Access Compliance Report

Public Rights-of-Way

(Curb Ramps)

Intersection ID: 42360	Main Street: KESTRAL RIDGE DR	Cross Street: OSPREY KNOLL DR	Location:	W
ADA ID: 813BE7FFE886	Ramp Type: PerpDiag	Initial Pass/Fail: Fail	Overall Compliance: No	Severity Score: 12.5
Codes/Mitigation Info/Possible Solution		Field Measurements/Component Compliance

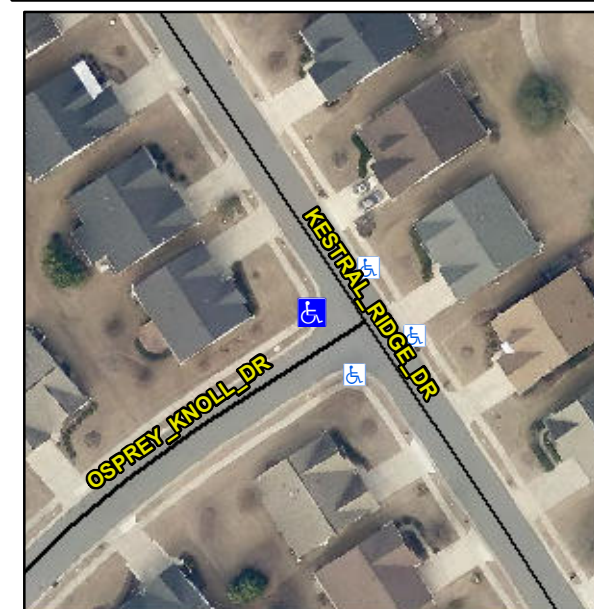
Not Found, R304.5.3

Compliance	Description	Data	Compliance	Description	Data
N/A	Ramp Length (in)	47.0	Yes	Ramp Slope (%)	6.3
Yes	Ramp Width (in)	72.0	No	Ramp XSlope (%)	6.0
N/A	Flare Type LT	N/A	N/A	Flare Type RT	N/A
N/A	Flare Slope LT (%)	N/A	N/A	Flare Slope RT (%)	N/A
N/A	Flare Traversable LT?	N/A	N/A	Flare Traversable RT?	N/A
N/A	Landing Length (in)	N/A	N/A	DWS Provided?	N/A
N/A	Landing Width (in)	N/A	N/A	DWS Contrast?	N/A
N/A	Landing Slope (%)	N/A	N/A	DWS Length (in)	N/A
N/A	Landing X Slope (%)	N/A	N/A	DWS Full Width?	N/A
N/A	Landing Curb? (Y/N)	N/A	N/A	DWS Offset (in)	N/A
N/A	Shared Landing?	N/A			
N/A	Gutter Ponding?	N/A	N/A	Gutter Slope (%)	N/A
N/A	Gutter Lip Ht (in)	N/A	N/A	Gutter X Slope (%)	N/A
N/A	Painted X Walk1?	No	N/A	Painted X Walk2?	No
	X Walk 1 Direction	To SE		X Walk 2 Direction	To NE
N/A	X Walk 1 Width (in)	N/A	N/A	X Walk 2 Width (in)	N/A
	X Walk 1 Slope (%)	1.1		X Walk 2 Slope (%)	4.4
	X Walk 1 X Slope (%)	4.1		X Walk 2 X Slope (%)	2.1

Remove & Replace Curb Ramp With Two New Directional Ramps or Equivalent.
